Amendments To The Drawings:

The attached drawing sheets include changes to FIGS. 1, 2, 4A and 4B.

REMARKS/ARGUMENTS

FIG.1
(RELATED ART)

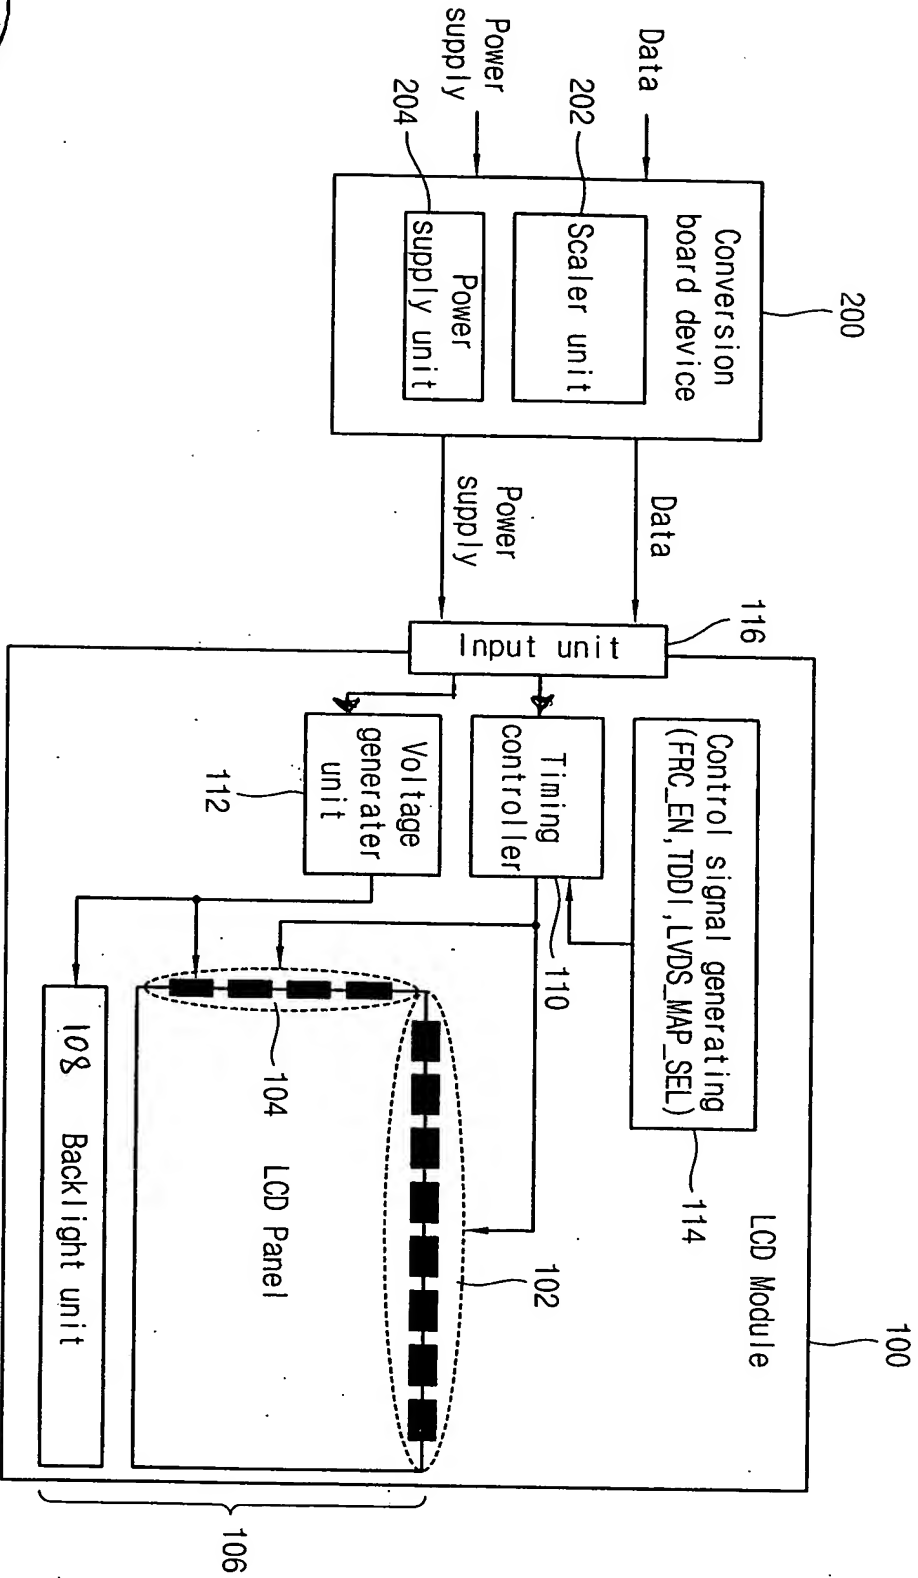
The Examiner noted that a connection is not shown between the "INPUT UNIT" and the "TIMING CONTROLLER" and "VOLTAGE GENERATING UNIT" on both FIG. 1 and FIG. 2. Correction has been made to FIG. 1 and FIG. 2 as shown in the attached drawing sheets.

In addition, reference numeral "108" has also been added to both FIG. 1 and FIG. 2. No new matter has been added to either FIG. 1 or FIG. 2.

FIG.4A

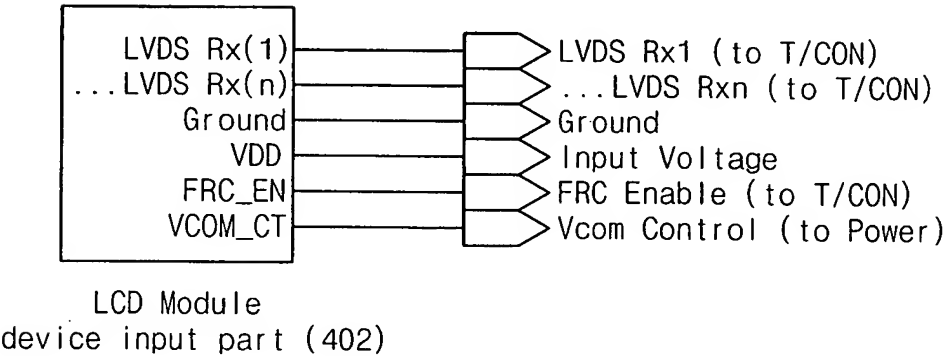
The legend "PRIOR ART" has been added to FIG. 4A and FIG. 4B.
